RE: Response to Comments
The Aurora Highlands PA-58 Neighborhood Park – Site Plan and Final Plat
2024-6011-00; 2024-3016-00

THE AURORA HIGHLANDS SUNSET PARK SITE PLAN

6 PICKLEBALL PLAN
1/4" = 1'-0"

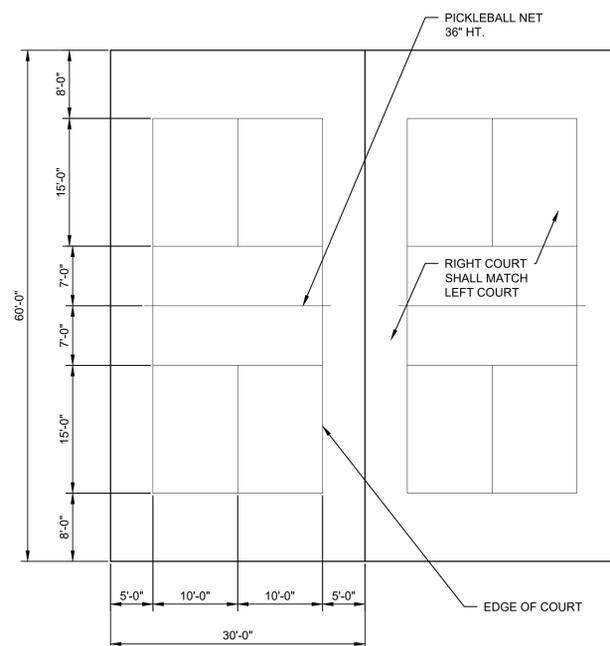
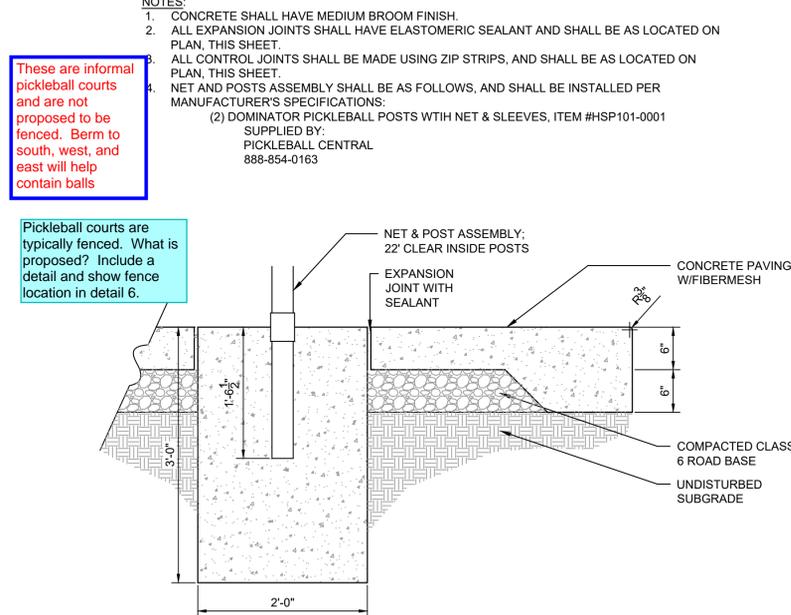
Pickleball courts are typically fenced. What is proposed? Include a detail and show fence location in detail 6.

These are informal pickleball courts and are not proposed to be fenced. Berm to south, west, and east will help contain balls

1 | ELECTRIC LIGHTING SITE - PHOTOMETRIC
 13 | SCALE: 1" = 40'

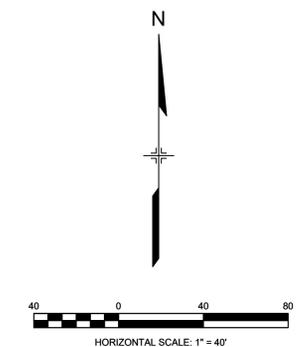
5J. SP Sheet #13: Will the lights be extinguished when the park is closed

Response: Lights will be on a timer to turn off when the park is closed.

Note added re: lights on timer to turn off when park is closed
